1. Speed Shop

REPORT TO THE DESIGN COMMISSION
from the DEVELOPMENT SERVICES DEPARTMENT

Permit Number: DR-2022-0001

Project Components: Design Review for construction of a new 17,000sf building addition and remodel of an existing 9,000sf building for a private auto club, project to include landscaping, utilities, pedestrian spaces and walkways for ESUV connections.

8. **2.5.3 Bike Rack Location**

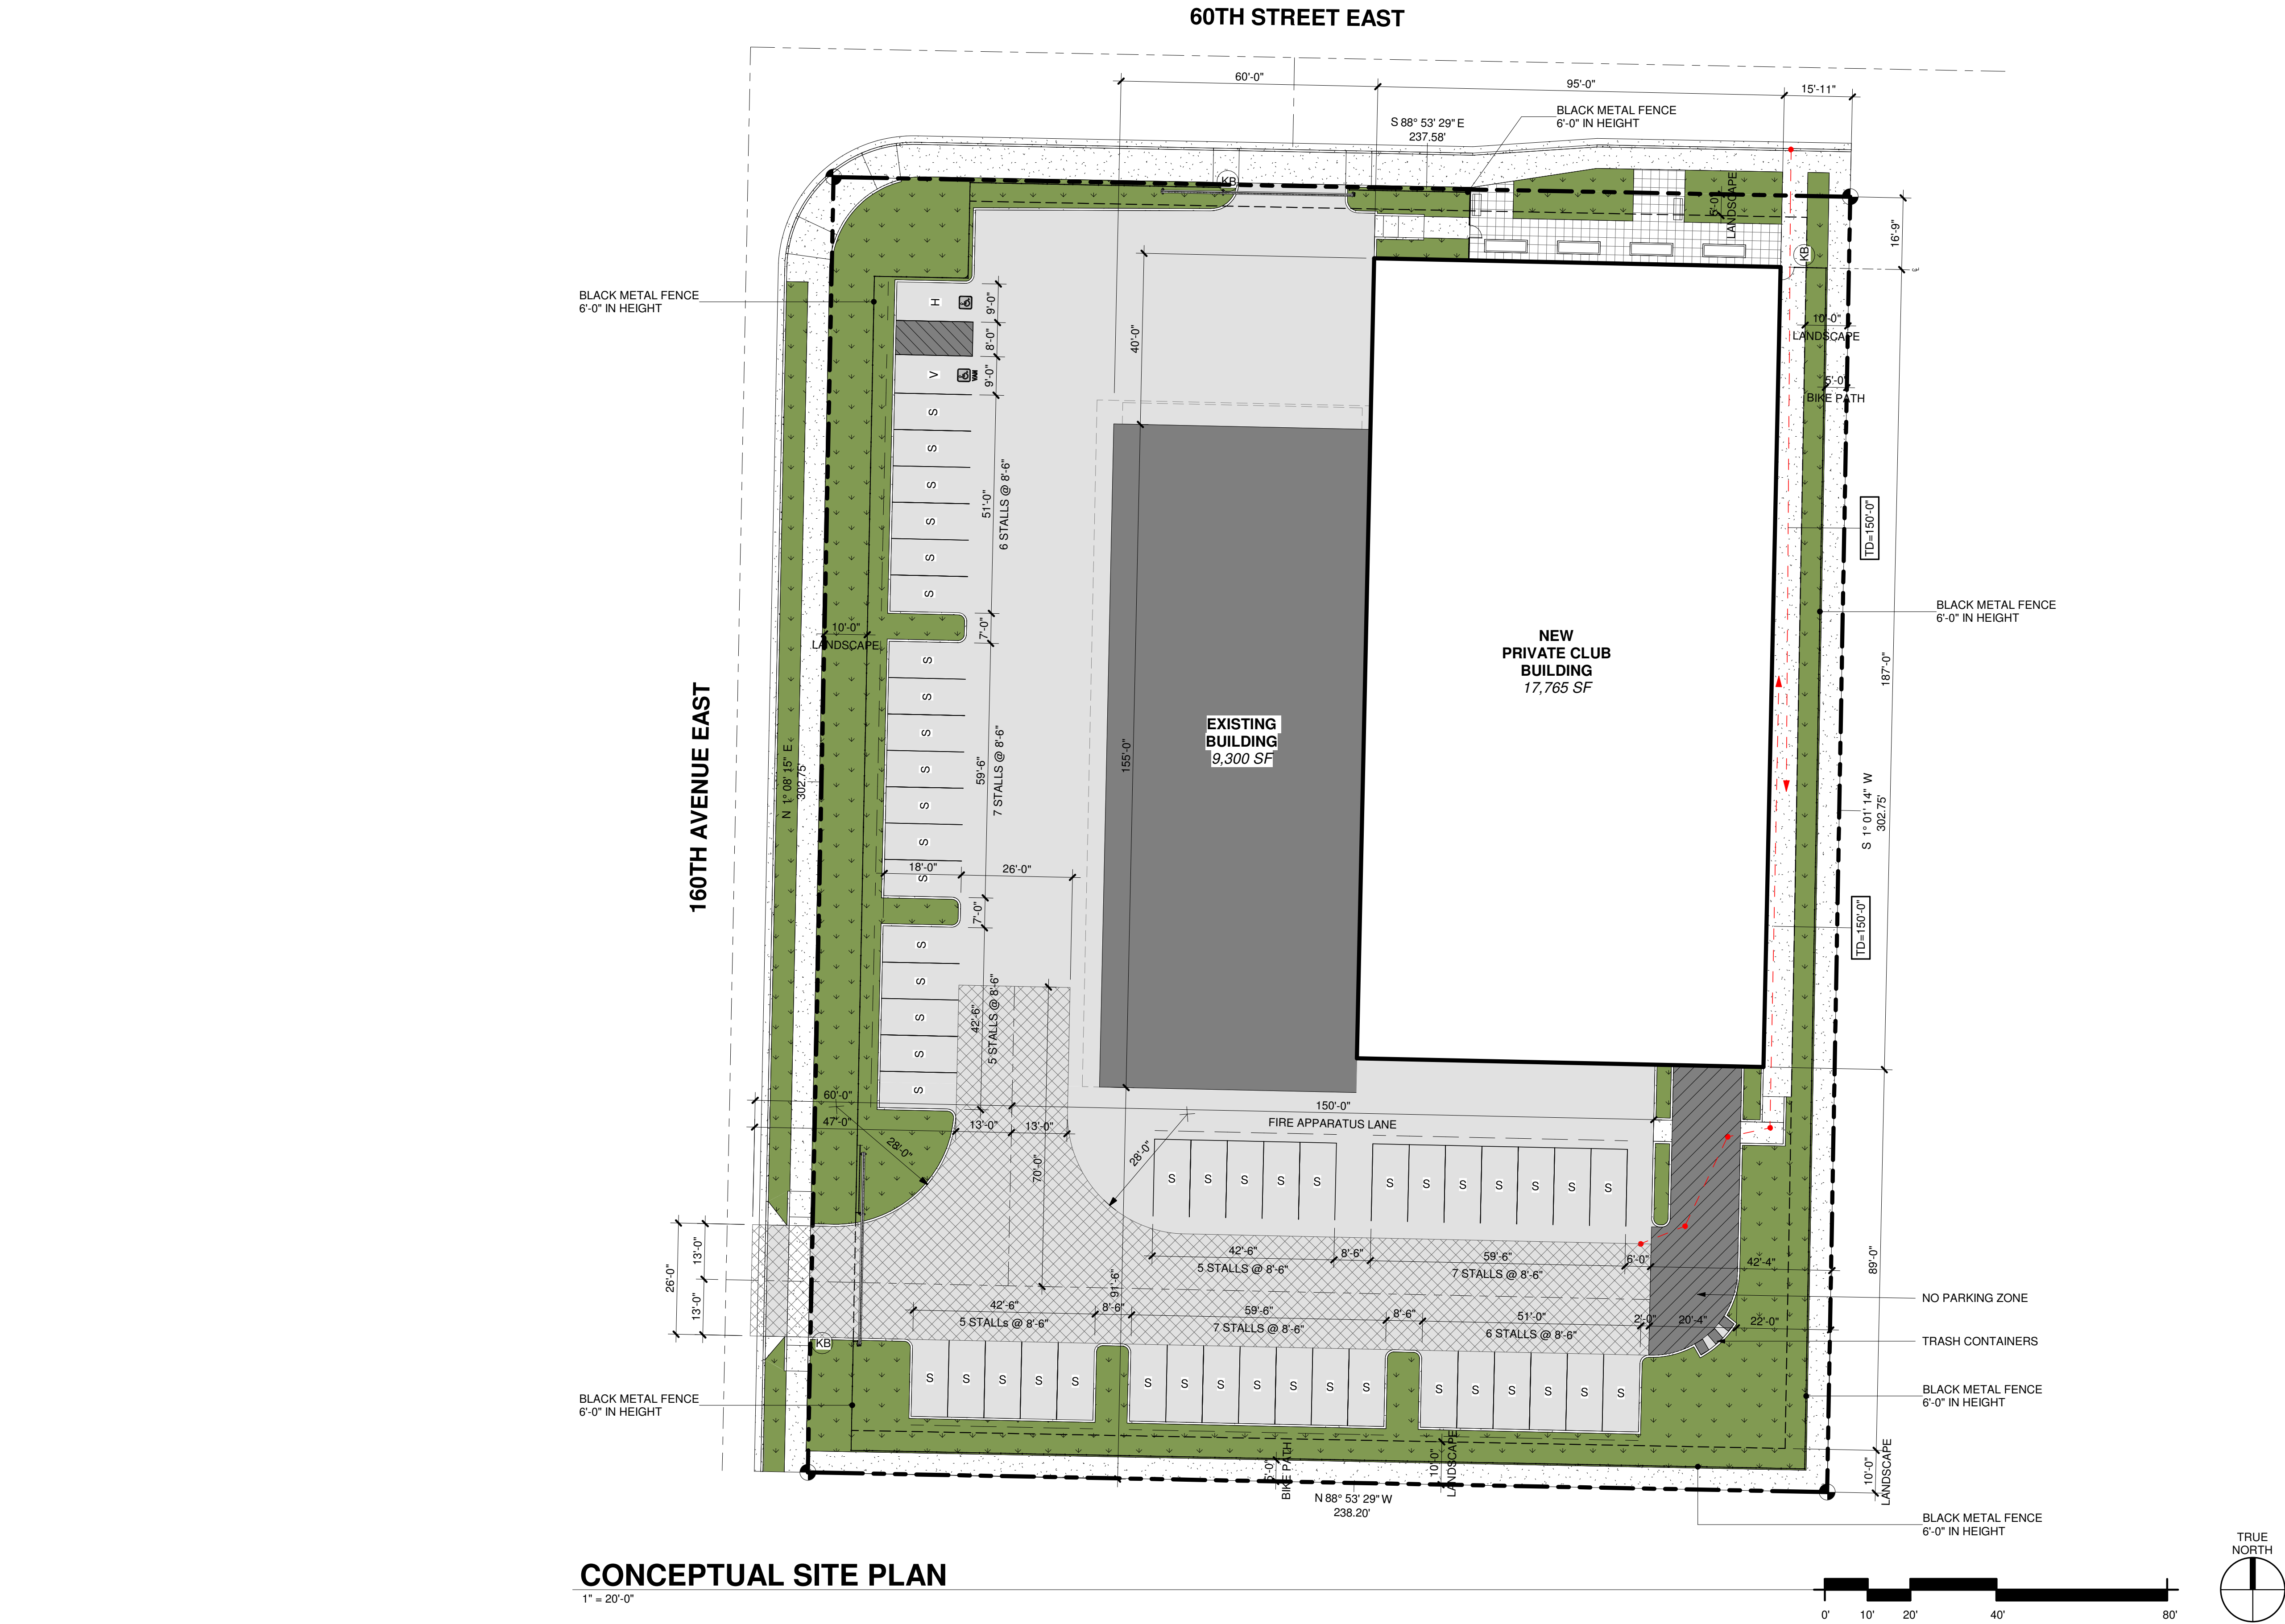
At time of development permit plans shall show bicycle parking to accommodate 5 bikes and its recommended to use a unique design that complements the pedestrian space in which its located.

EXTERIOR ELEVATION - NORTH - 60TH STREET

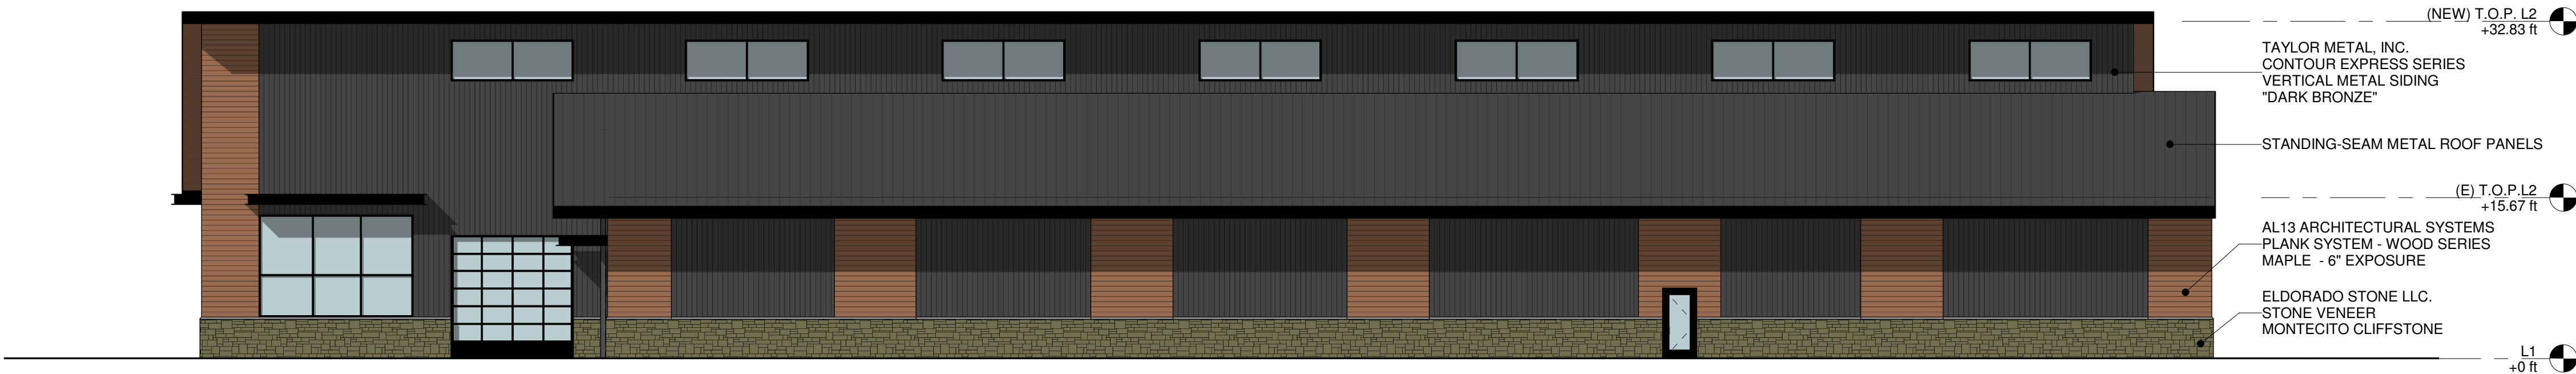
This project includes the use of storefront windows, change in building materials and weather protection along 60th Street E. This guideline is satisfied.
